Date: 1/9/04
To: T10 Committee (SCSI)
From: George Penokie (IBM/Tivoli)
Subject: SAS UML Corrections

Figure 6 — SAS domain class diagram

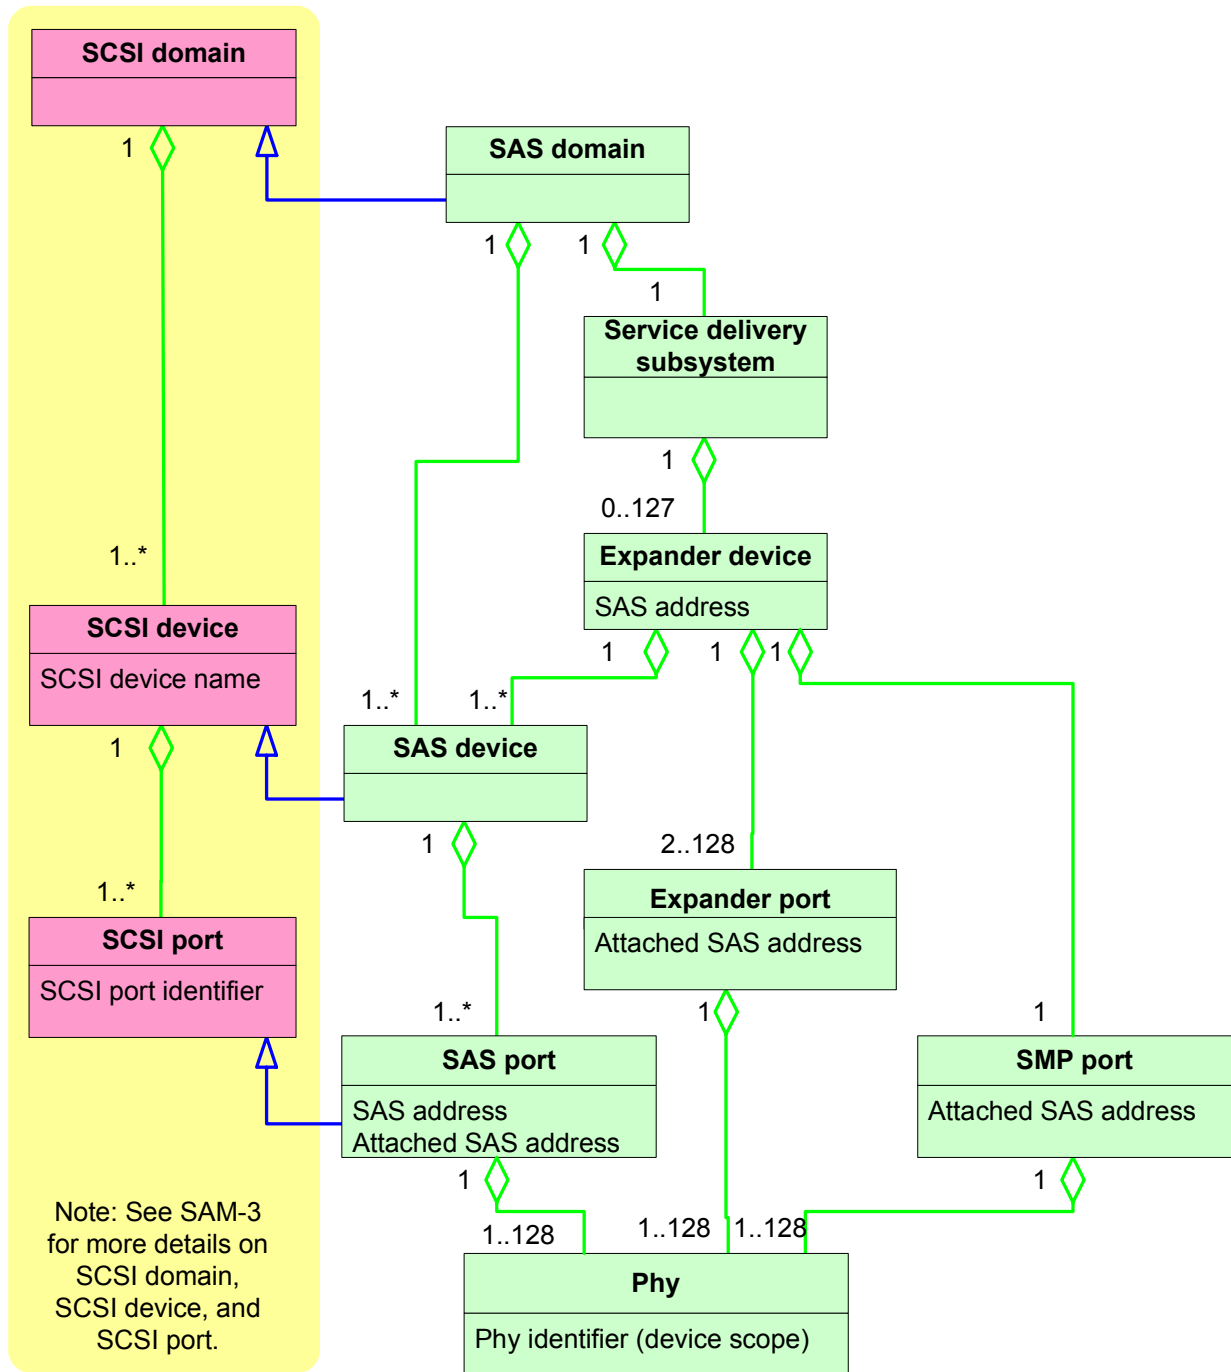
Figure 6 shows the class diagram for a SAS domain, showing the relationships between SAS domain, SCSI domain, service delivery subsystem, expander device, expander port, SAS device, SCSI device, SAS port, SCSI port, and phy classes. Relationships to ATA classes (e.g., ATA domain) are not shown in figure 6.

Figure 7 — Phy classes and phy objects

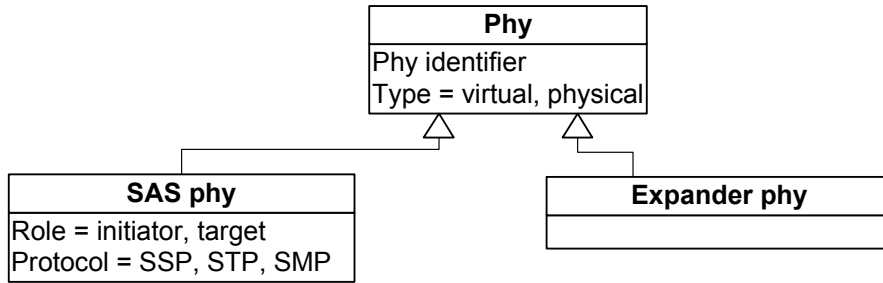
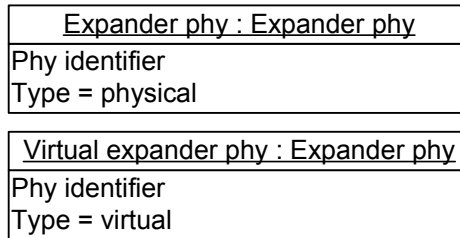
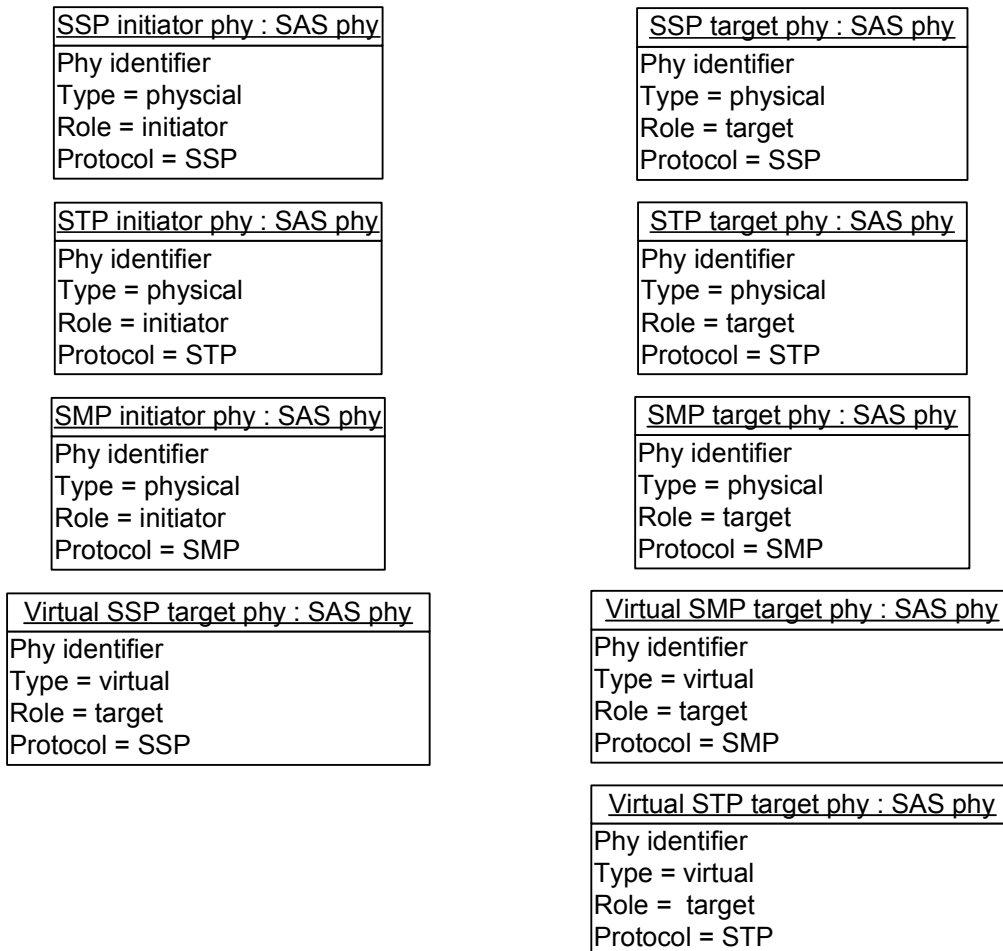
Figure 7 shows phy classes and the objects that are instances of the SAS phy and expander phy classes, showing the relationships between phy, SAS phy, and expander phy classes and the SSP initiator phy, SSP target phy, STP initiator phy, STP target phy, SMP initiator phy, SMP target phy, virtual SSP target phy, virtual

SMP target phy, virtual STP target phy, expander phy, and virtual expander phy objects. SATA phys are also referenced in this standard but are defined by SATA (see ATA/ATAPI-7 V3).

The objects of the SAS phy class shown in figure 7 are only valid and unchangeable during a connection. A different object may be used on a different connection.

Figure 8 — SAS Phy classes

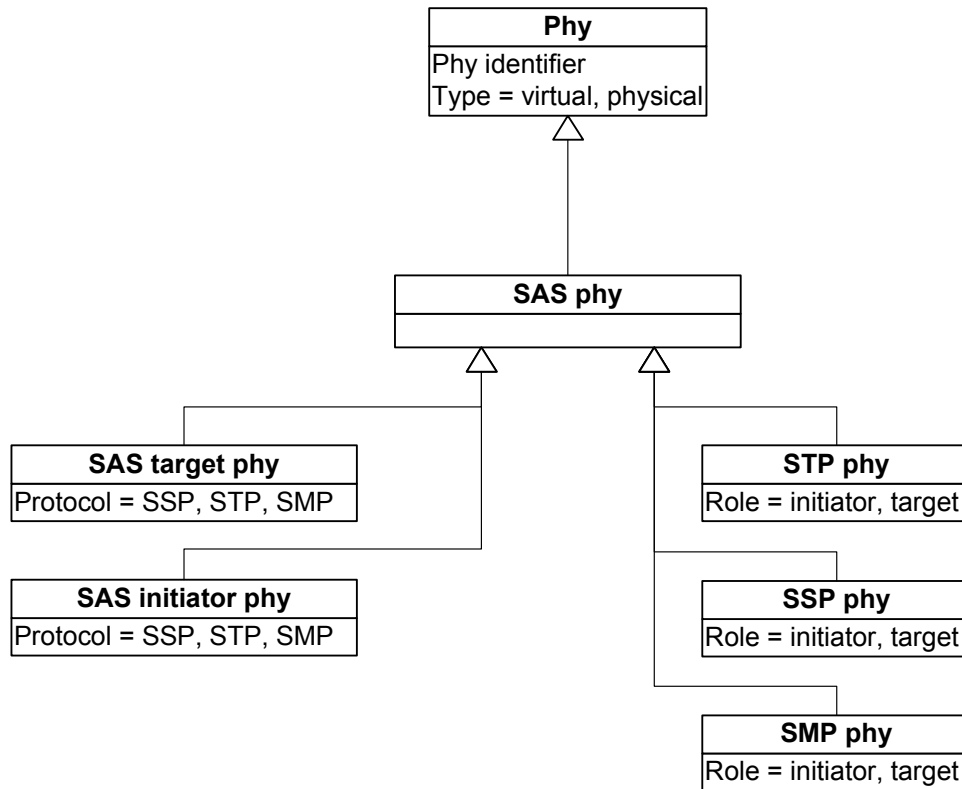
Figure 8 shows an expansion of the SAS phy class, showing the relationships between phy, SAS phy, SAS initiator phy, SAS target phy, SSP phy, STP phy, and SMP phy objects. SATA phys are also referenced in this standard but are defined by SATA (see ATA/ATAPI-7 V3).

Figure 9 — Port classes and port objects

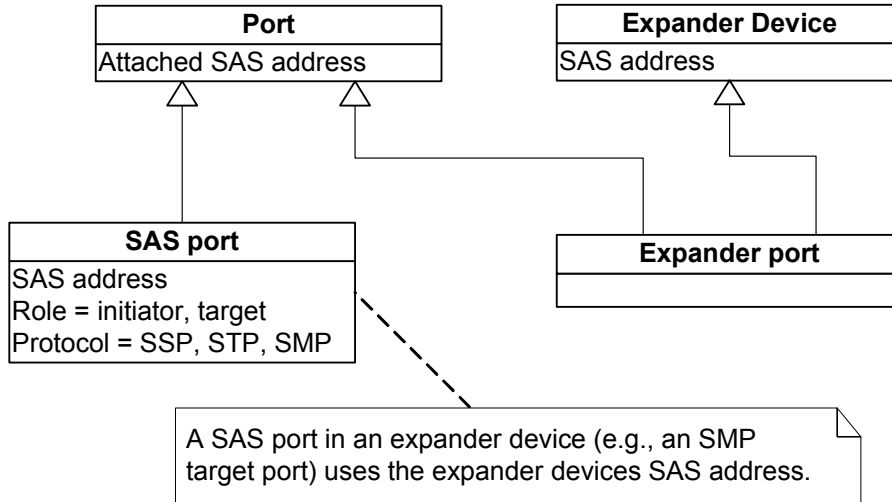
Figure 9 shows the port classes and the objects that are instances of the SAS port and expander port classes, showing the relationships between port, expander device, expander port, and SAS port classes and the SSP initiator port, STP initiator port, SMP initiator port, SSP target port, STP target port, SMP target port, and expander port objects.

The objects of the SAS port class shown in figure 9 are only valid and unchangeable during a connection. A different object may be used on a different connection

Figure 10 — SAS Port classes

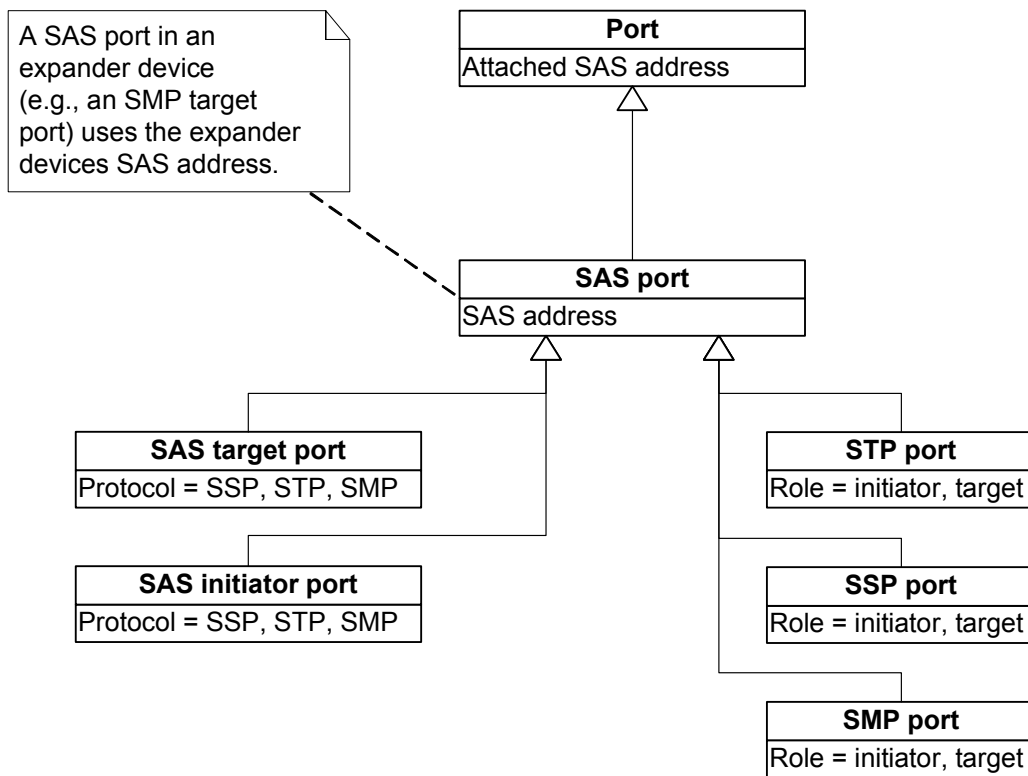
Figure 10 shows an expansion of the SAS port class, showing the relationships between port, SAS port, SAS initiator port, SAS target port, SSP port, STP port, and SMP port classes.

Figure 11 — Expander device classes

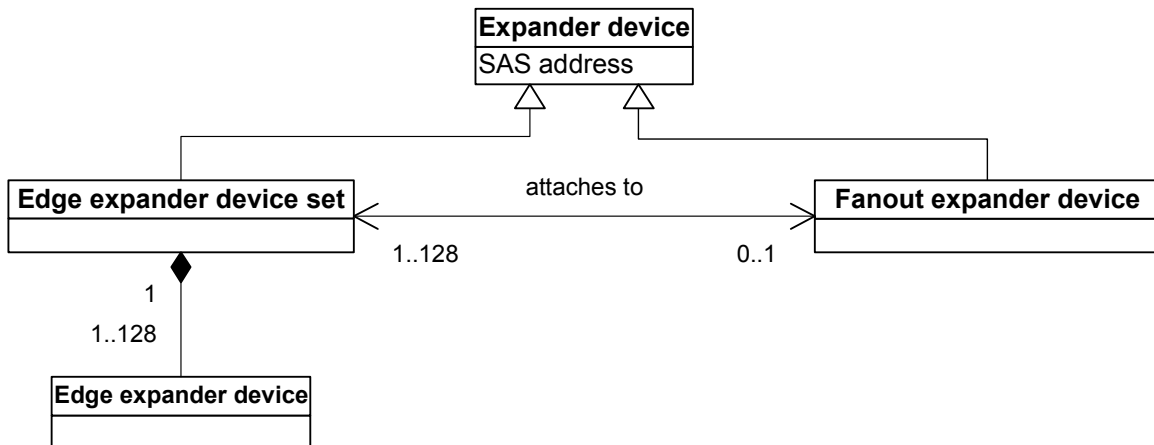
Figure 11 shows the expander device classes.

Figure 12 — State machines for SAS devices

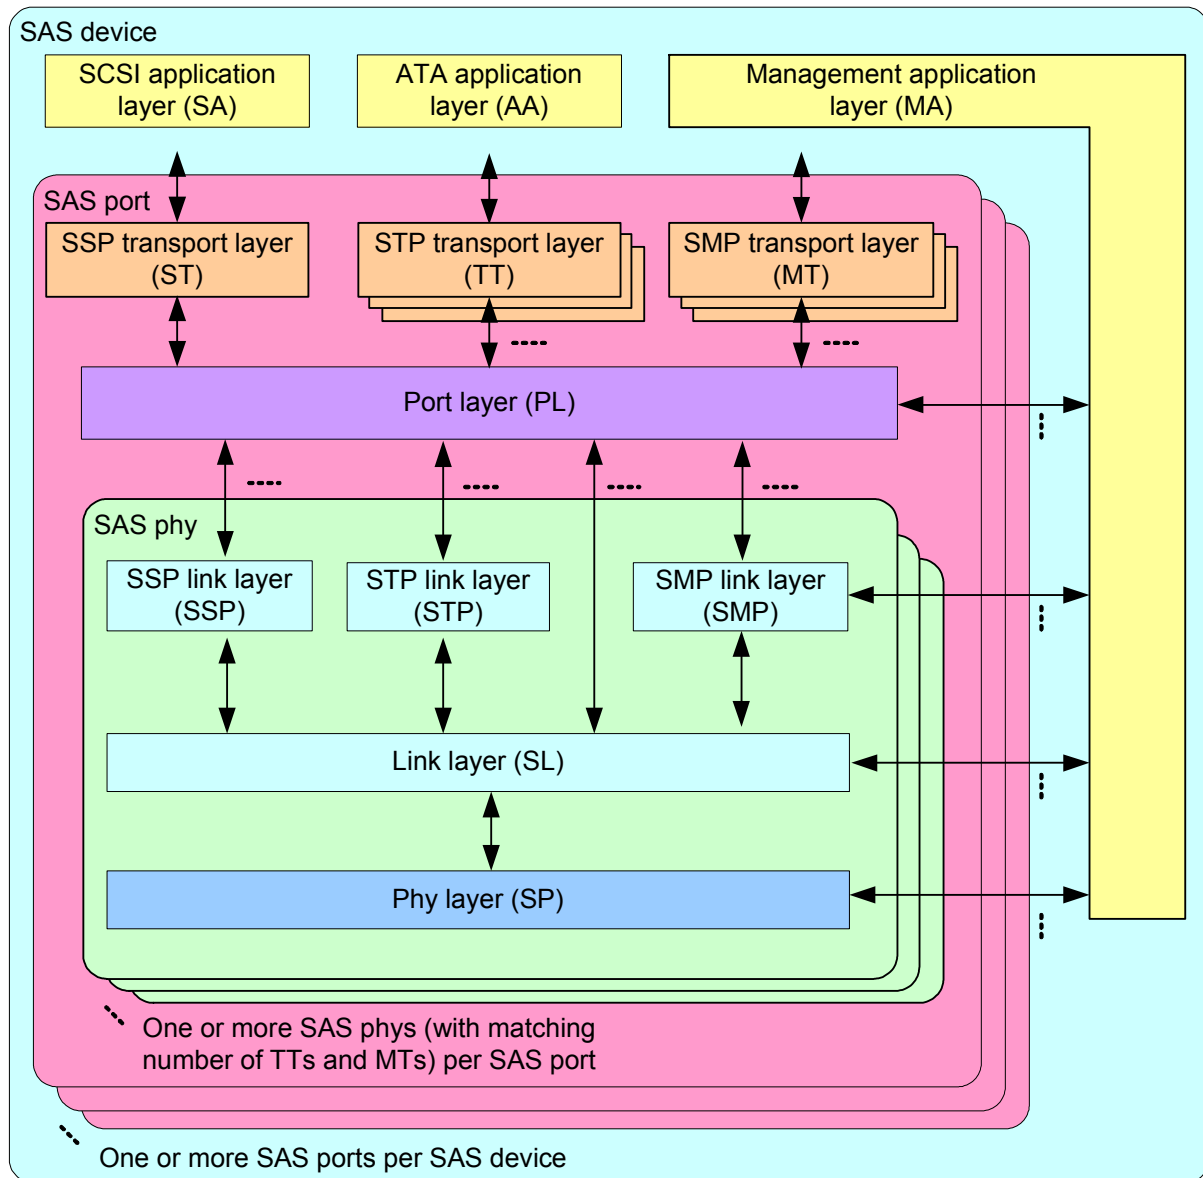
Figure 12 shows the state machines for SAS devices, their relationships to each other and to the SAS device, SAS port, and SAS phy.

Figure 13 — State machines for expander devices

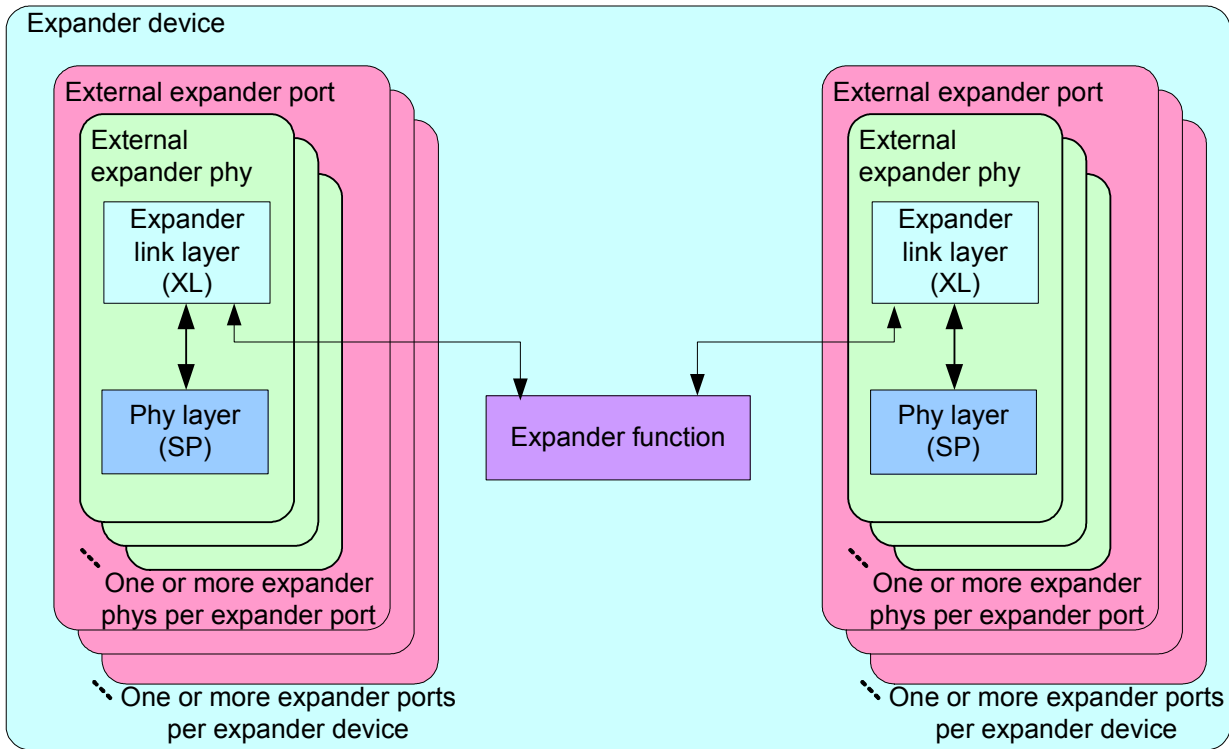
Figure 13 shows the state machines for expander devices, their relationships to each other and to the expander device, expander port, and expander phy. Expander function state machines are not defined in this standard, but the interface to the expander function is defined in 4.6.6.

Figure 14 — State machine and SAS device, SAS port, and SAS phy classes

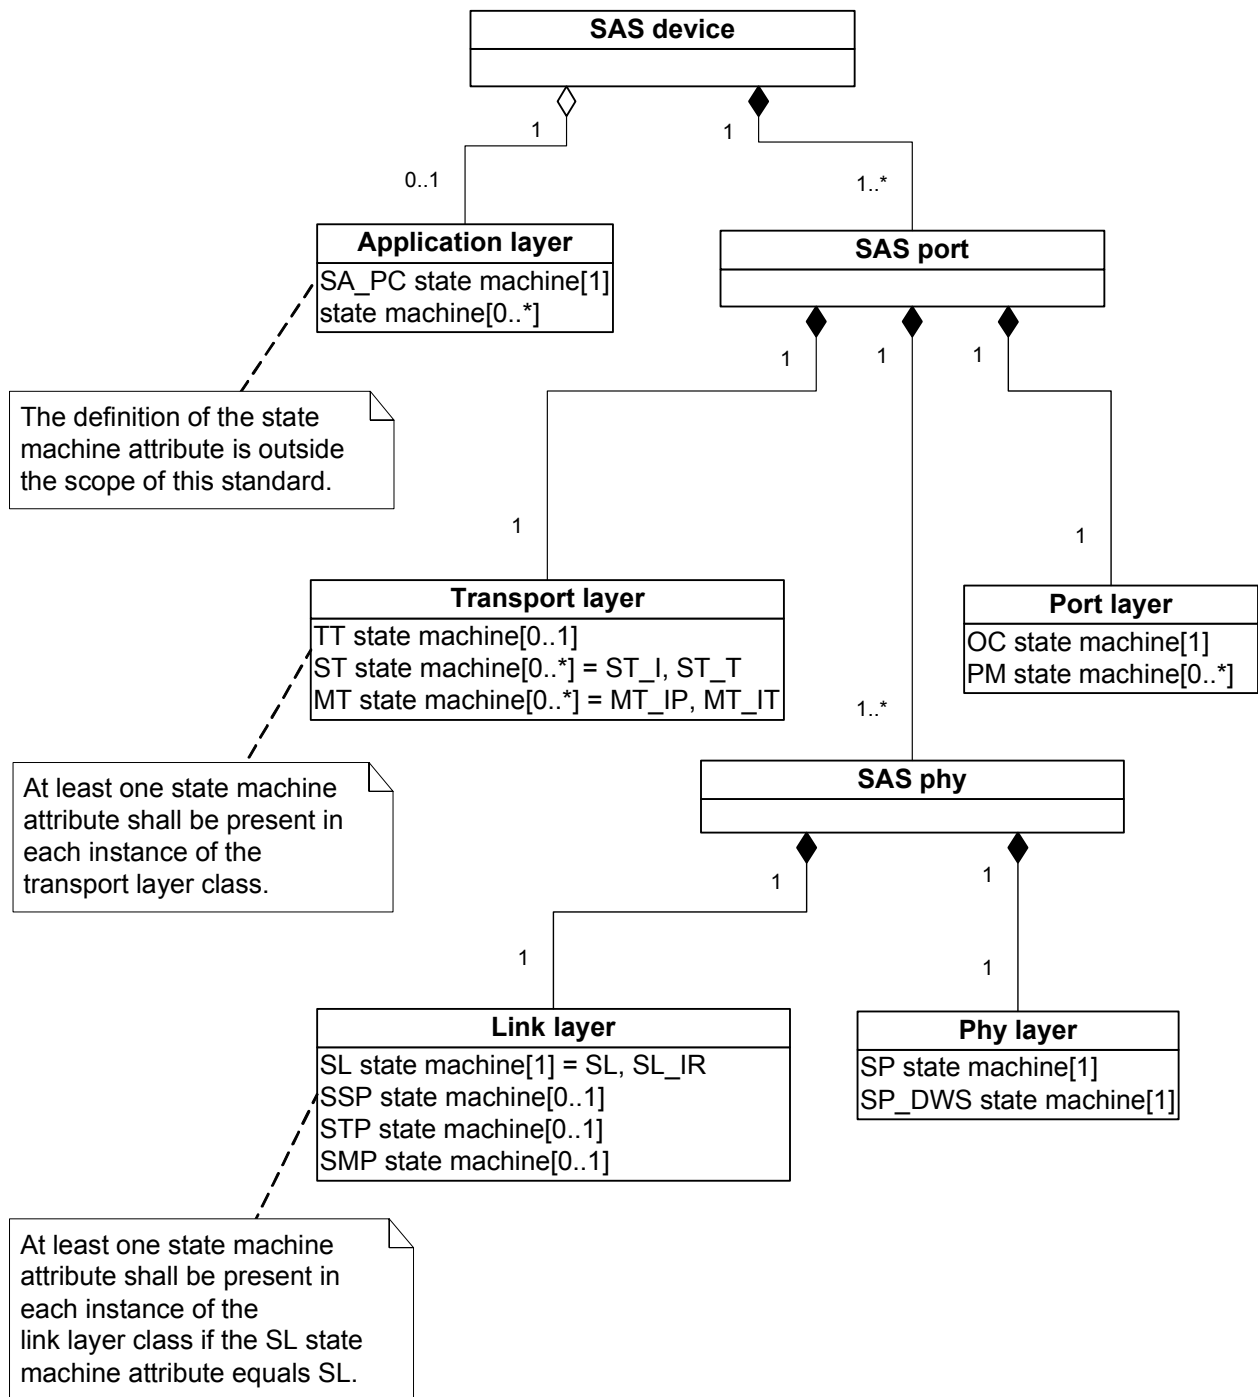
Figure 14 shows which state machines are contained within the SAS device, SAS port, and SAS phy classes.

Figure 15 — State machine and expander device, expander port, and expander phy classes

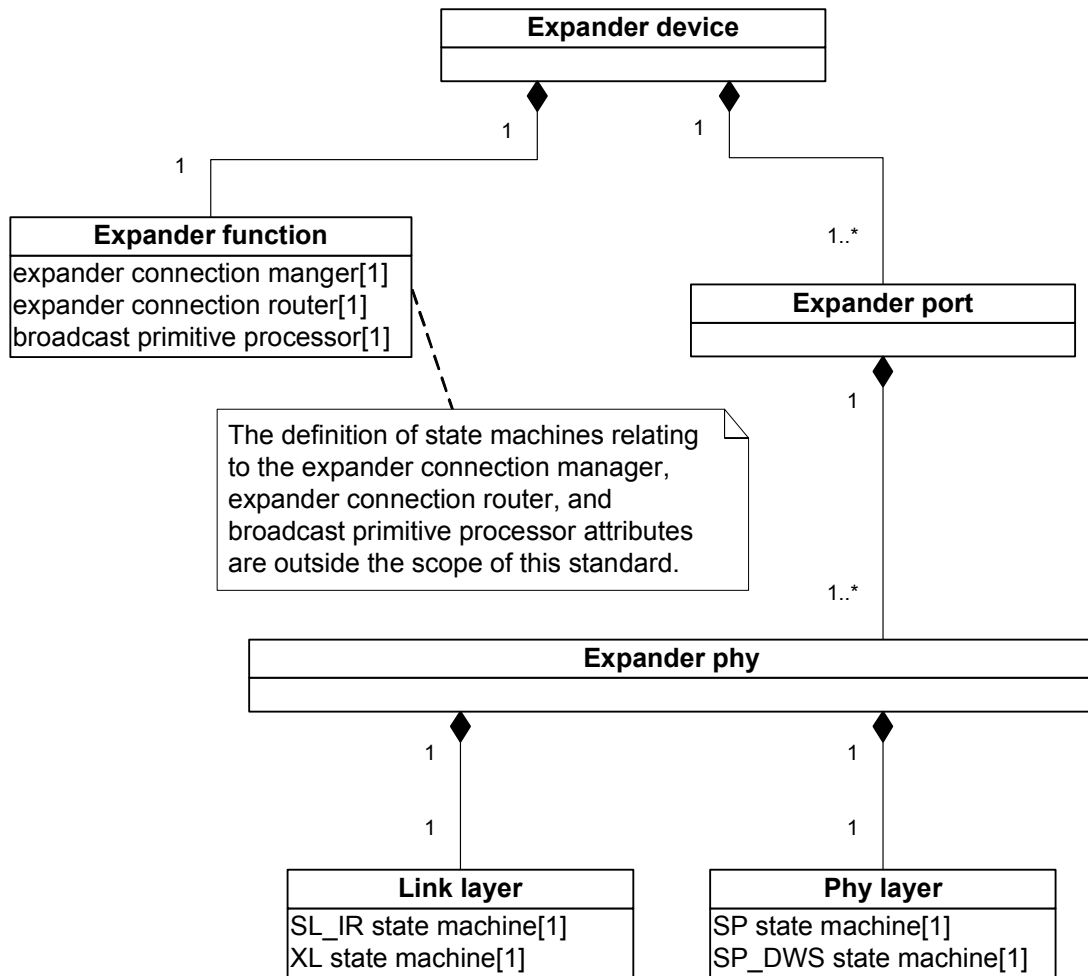
Figure 15 shows which state machines are contained within the expander device, expander port, and expander phy classes.
